January 31, 2004
BVY 04-009

**Subject: Vermont Yankee Nuclear Power Station
License No. DPR-28 (Docket No. 50-271)
Technical Specification Proposed Change No. 263 – Supplement No. 4
Extended Power Uprate – NRC Acceptance Review**

Figure 5 Dryer Model – Dryer Support Structure

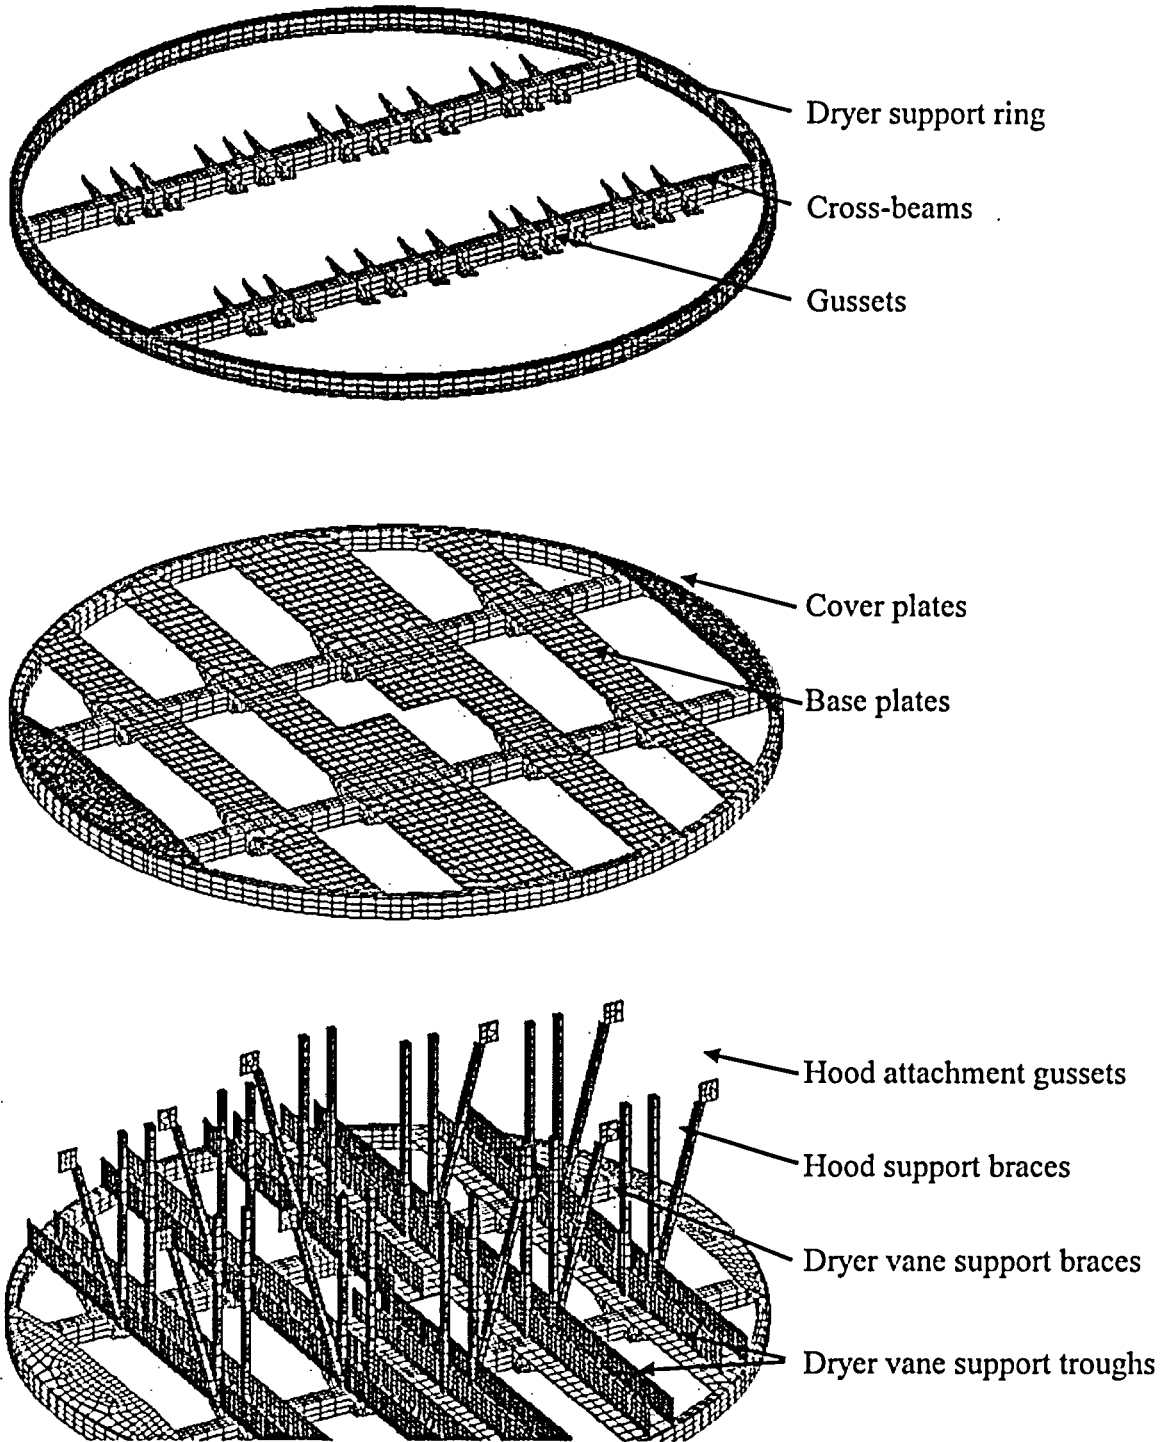
5.	A stress failure acceptance criterion of 27,200 psi is used for assessment of steam dryer components. This value is twice the ASME curve C (ASME Section III, 1986, Division 1, Appendix I, Figure I-9.2.2, Design Fatigue Curve for Austenitic Steels) value.	The VYNPS steam dryer is a non-safety related component and, while it is considered robust, was not originally designed nor rigorously analyzed for the effects of FIV. Therefore it is considered appropriate that a value of twice the ASME design fatigue curve is used to represent the mean of the failure curve. The ASME criteria for service cycles equal to 10^{11} are given in ASME Section III, 1986, Division 1, Appendix I, Figure I-9.2.2, Design Fatigue Curve for Austenitic Steels.

The modified VYNPS steam dryer is analyzed using the process described in Section 1 of this response. In addition, the fatigue loading acceptance criterion for the modified steam dryer is 13,600 psi, corresponding to the ASME Section III, 1986, Division 1, Appendix I, Figure I-9.2.2, Design Fatigue Curve for Austenitic Steels. Entergy will install the steam dryer modifications in the plant refueling outage prior to planned operation at Extended Power Uprate conditions, April 2004.
